Technical Service Bulletin: TSB200079	Released Date: 31-Mar-2020
Heat Exchanger Main Support Bracket Installation

Heat Exchanger Main Support Bracket Installation

Figure 1, Location of Capscrews to be Replaced

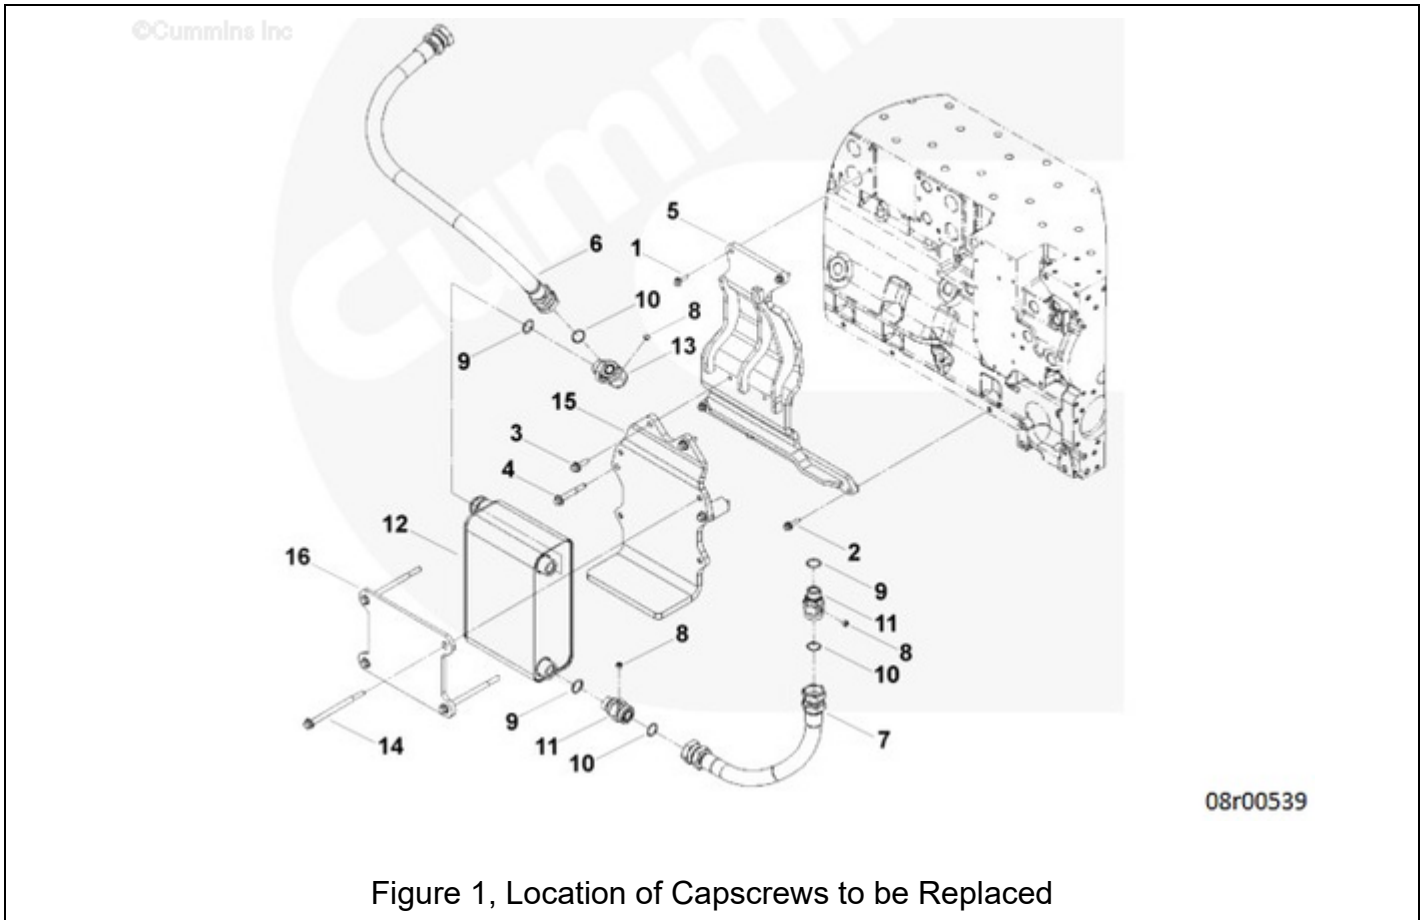
- Broken capscrews found on the heat exchanger main support bracket to engine cylinder block.

- Capscrew strength insufficient.

Verify heat exchanger main support bracket capscrews are broken.

Higher grade capscrews are now available. Reference Service Instruction section below.

Replace broken capscrews shown in location 1 and 2 in Figure 1 below with new higher grade capscrews. Reference Table 1 below for applicable part numbers.
